**Addendum No. 1**

Addendum No.1 form shall be part of the original ITB NO. 23-10 FRANJO ROAD ROADWAY IMPROVEMENTS PROJECT document and modifies the original ITB as noted below:

**Invitation to Bid (ITB) No. 23-10  
FRANJO ROAD ROADWAY IMPROVEMENTS PROJECT  
Town of Cutler Bay  
Florida Town Project ITB  
No. 23-10**

FRANJO ROAD

MIAMI-DADE COUNTY PUBLIC WORKS DEPT.  
 HIGHWAY DIVISION  
 FRANJO ROAD  
 FROM OLD OUTLER RD TO SW 184th STREET  
 PROJECT NO. 20190519  
 SHEET C-36 OF 82

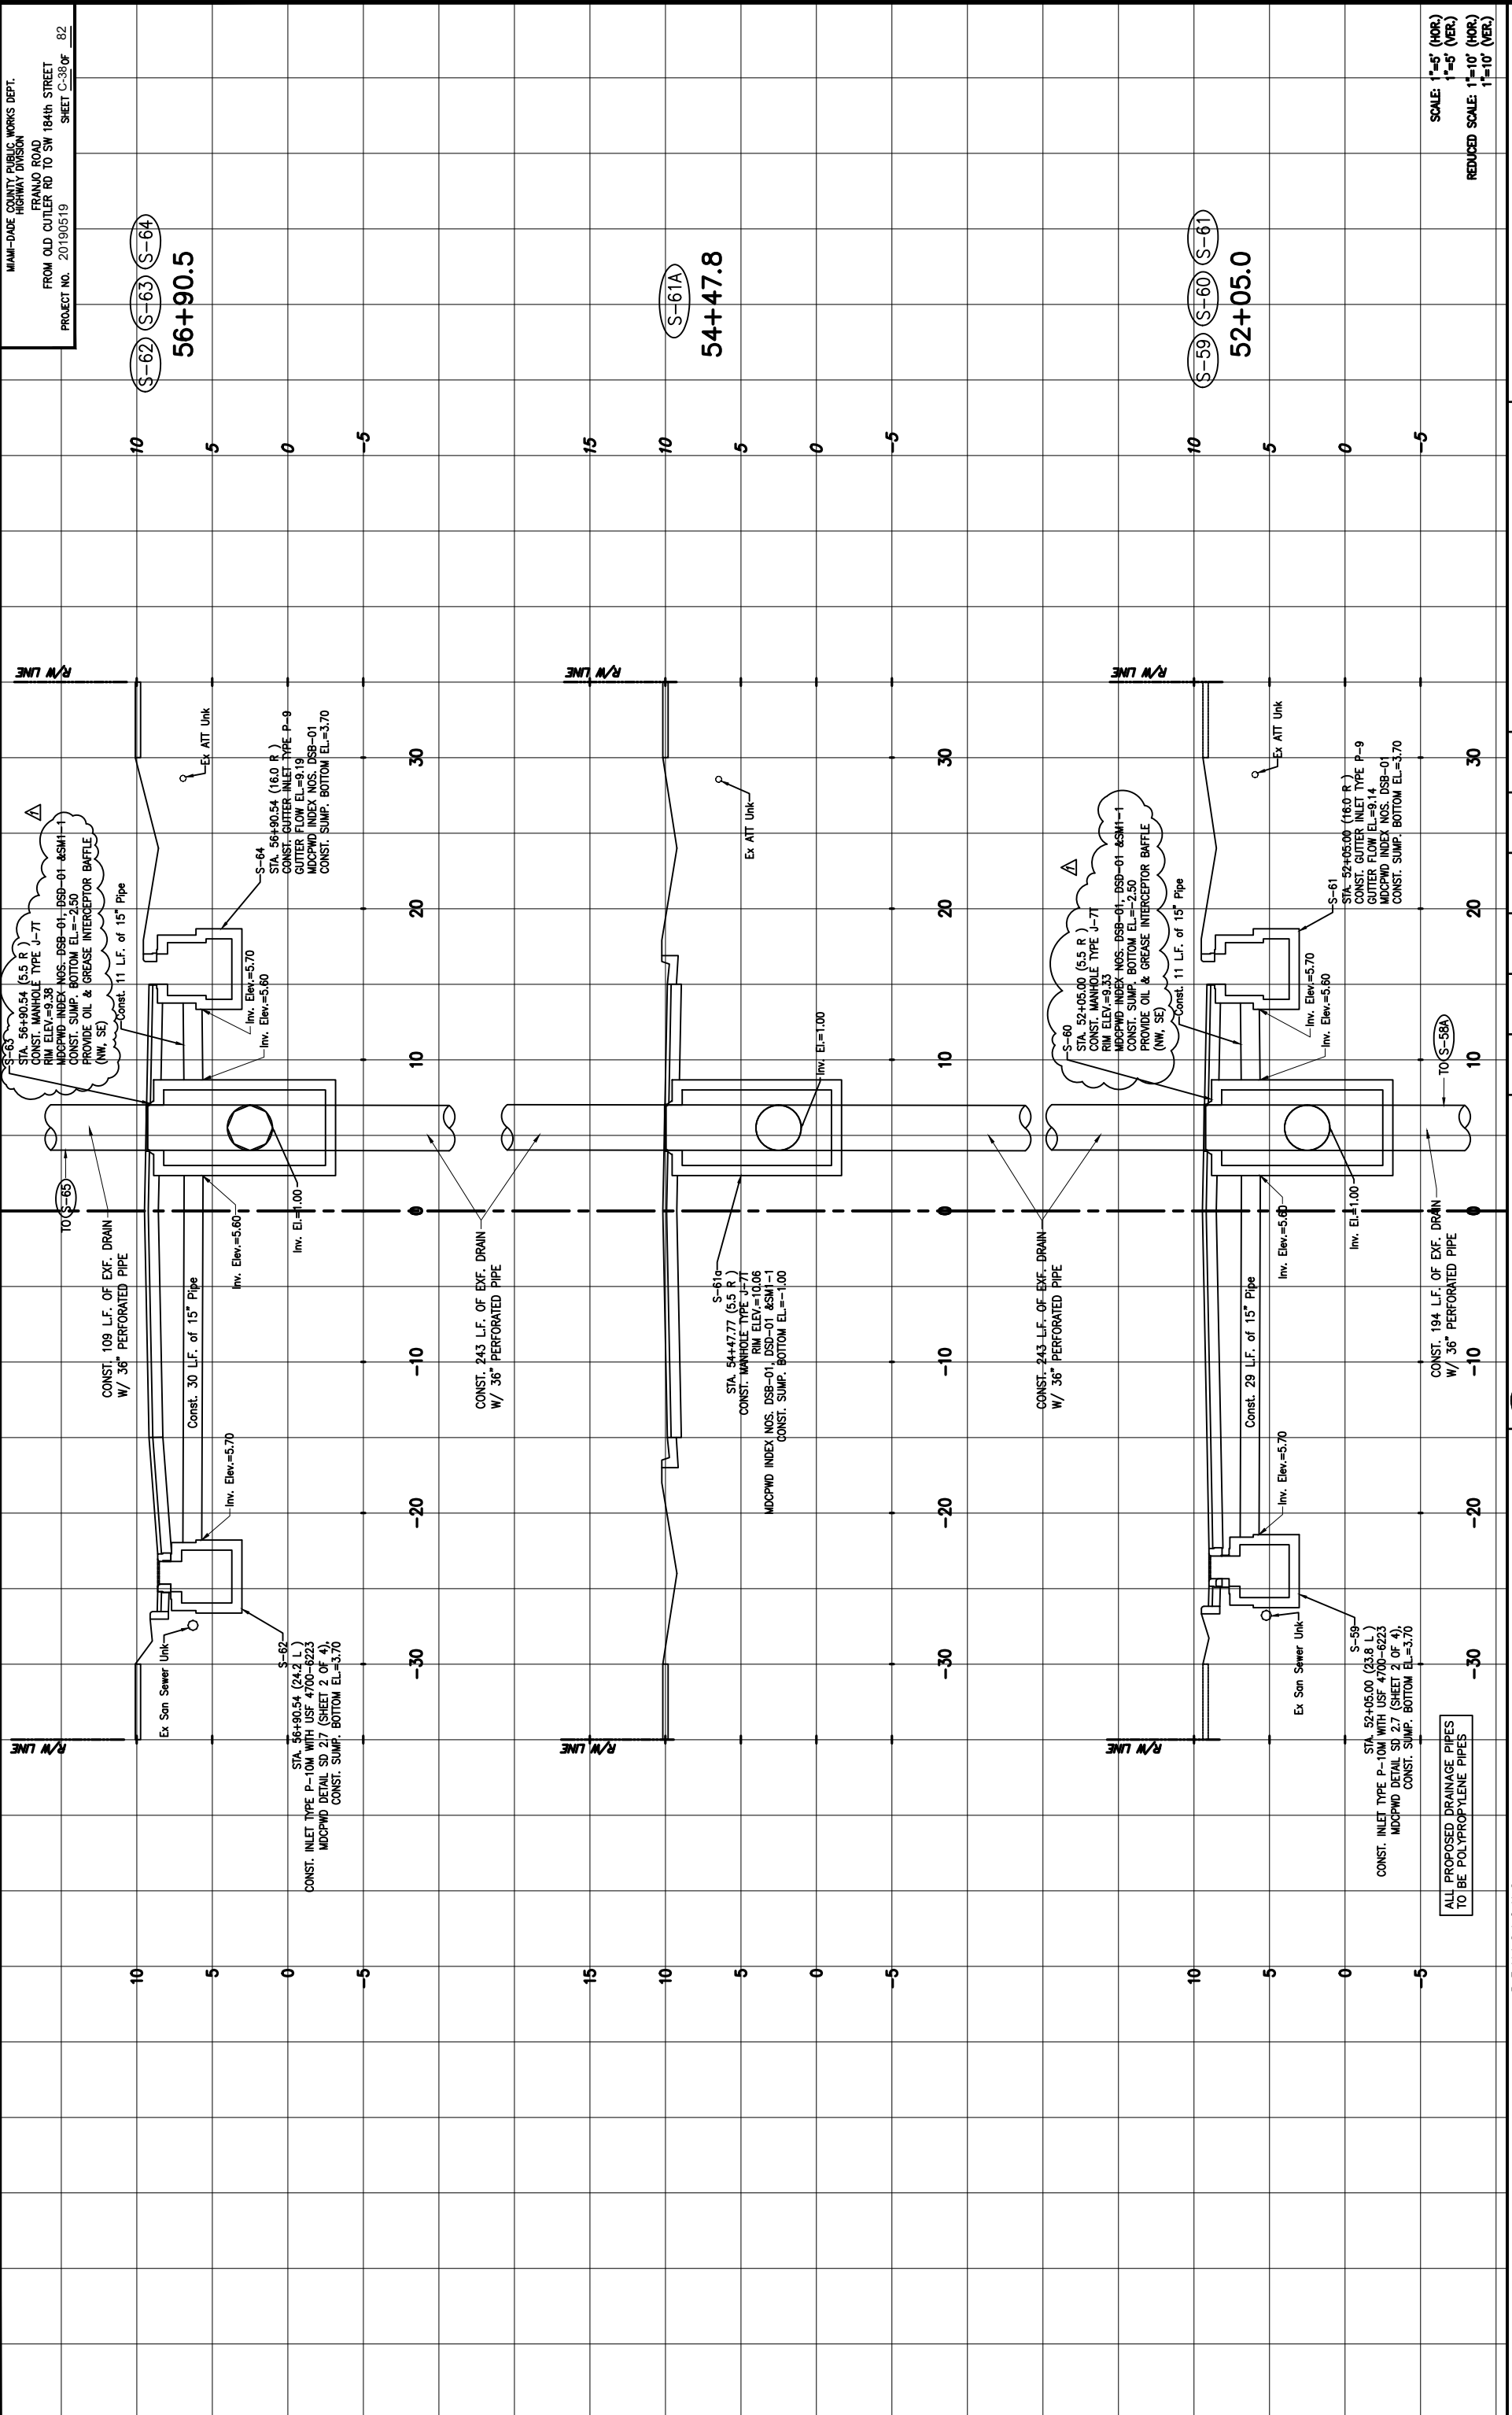
REVISION	DATE	DESCRIPTION
		ALL PROPOSED DRAINAGE PIPES TO BE POLYPROPYLENE PIPES
